RE: 34 Circle Court (667-1) – Parking Lot and Walkway Upgrades
North Attleborough Housing Authority
Additional Information

PARKING LOT & WALKWAY UPGRADES

CIRCLE COURT (667-1)

SITE PLAN REVIEW FOR (NAHA)
NORTH ATTLEBOROUGH HOUSING AUTHORITY
100% CONSTRUCTION DOCUMENTS

### SITE PLAN - CIRCLE COURT

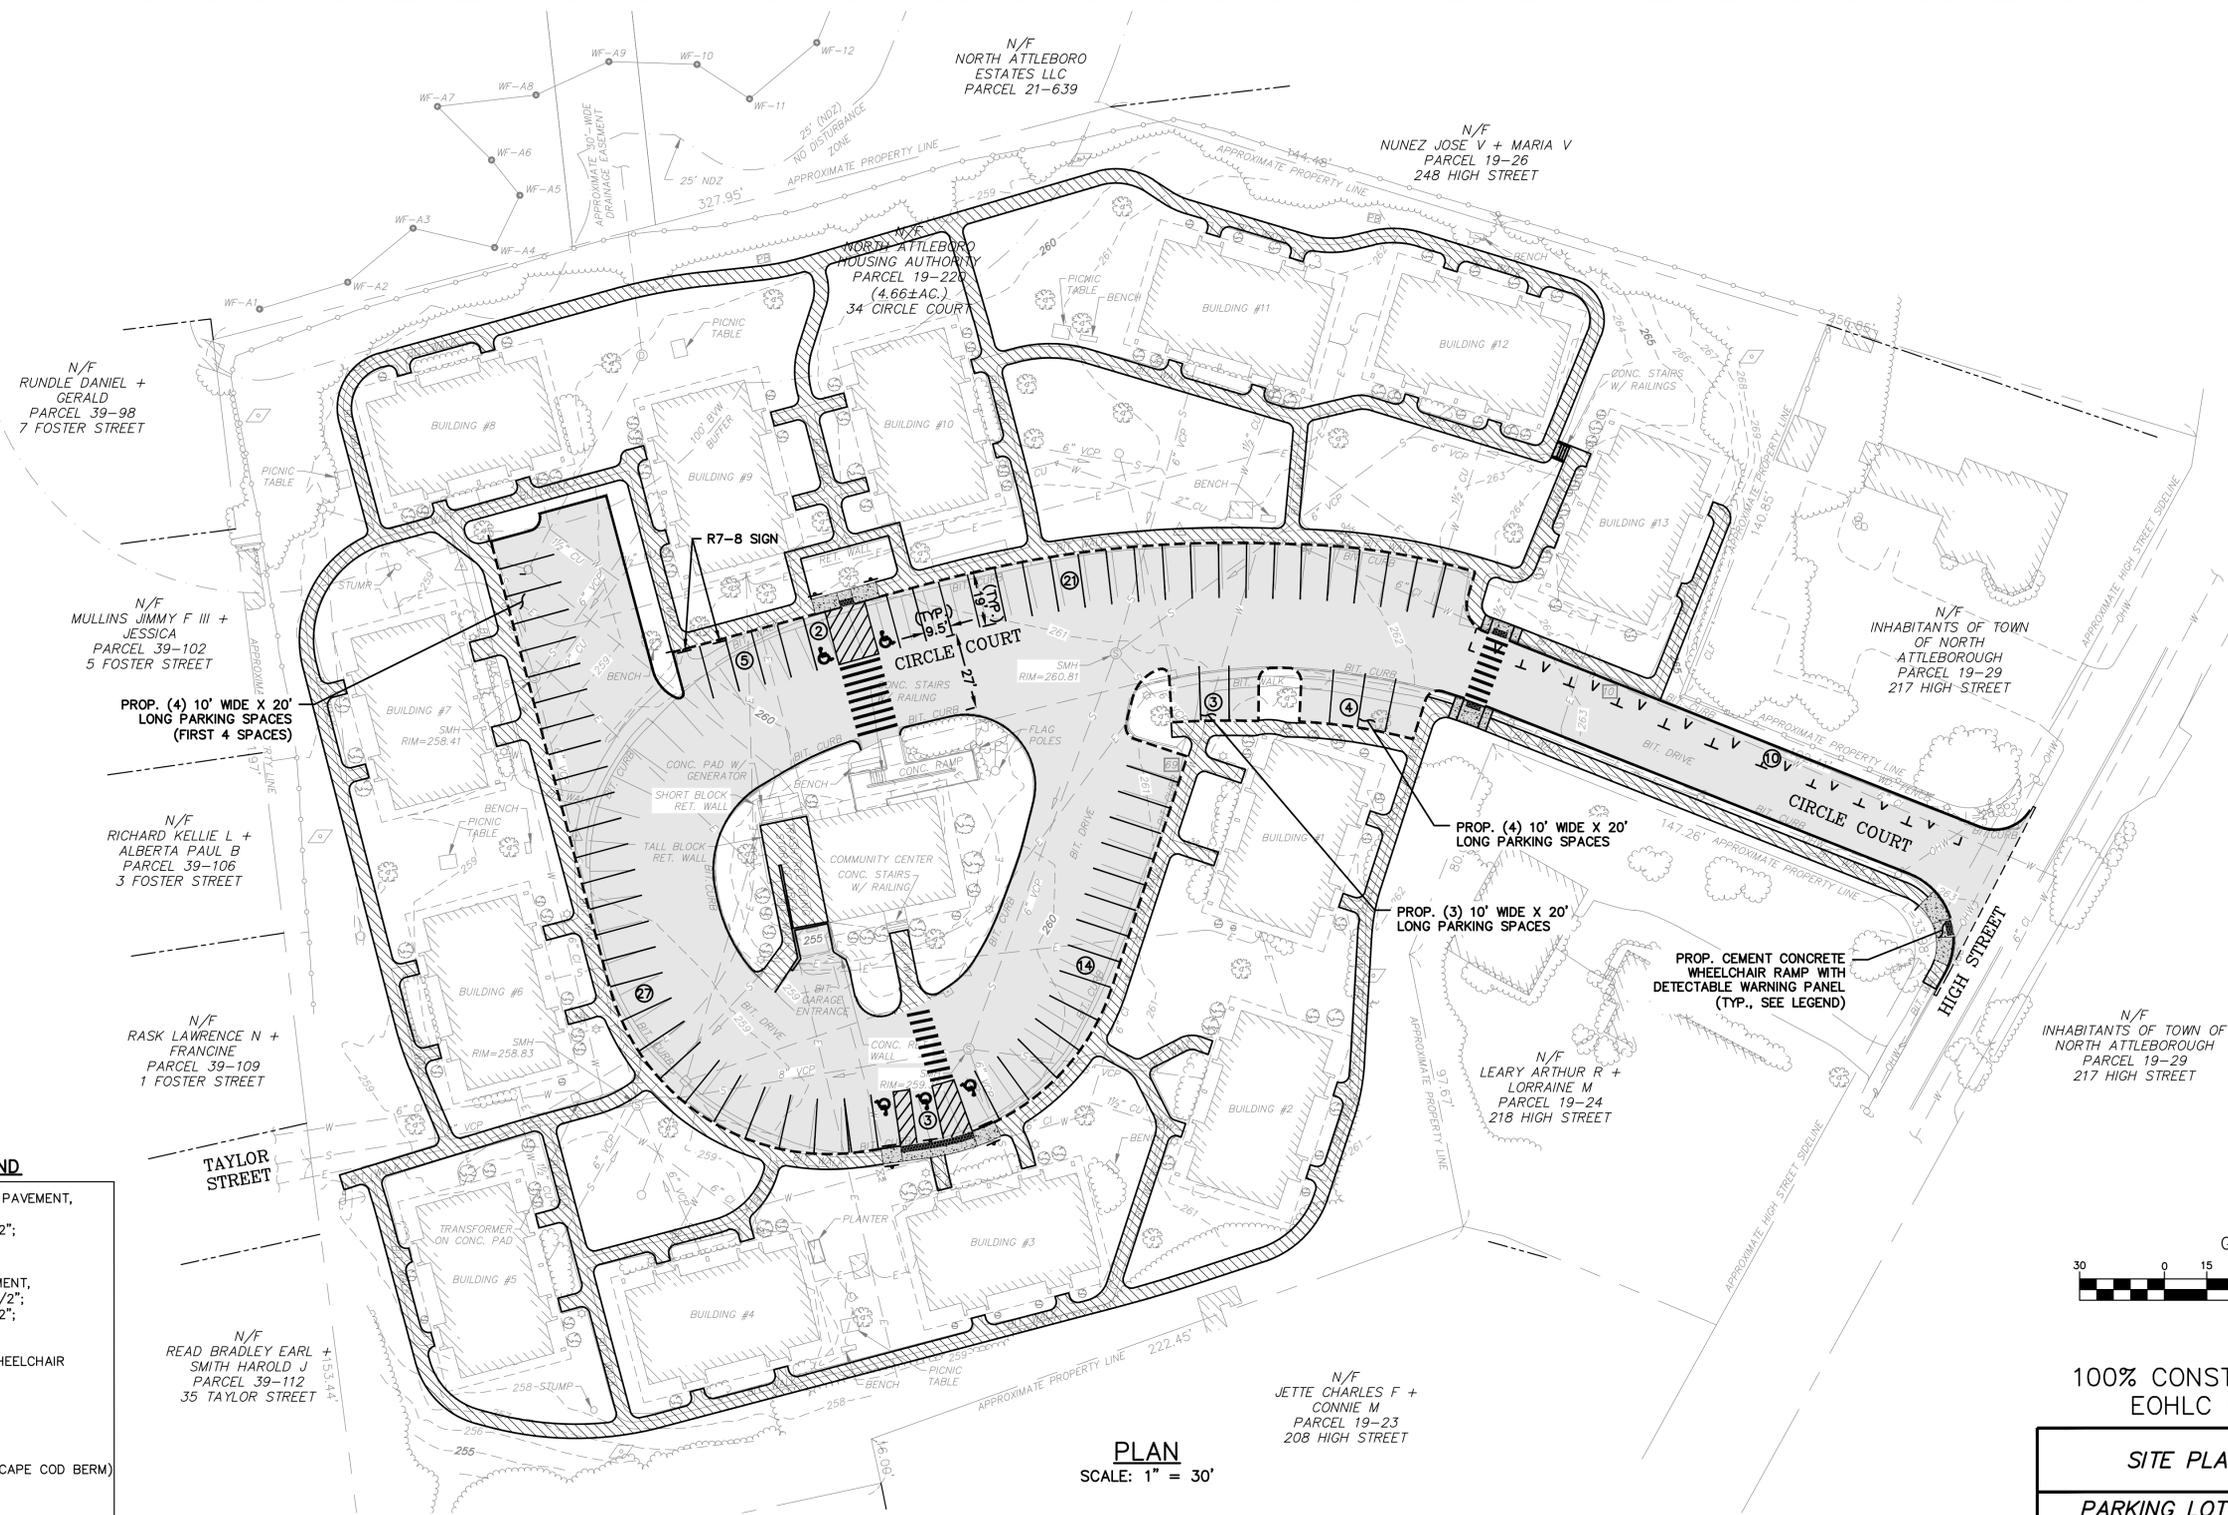
- The ten new parking spaces will be stripped as 10'x20'.
- Two ADA ramps and crosswalk have been added as suggested along the road entering the site.
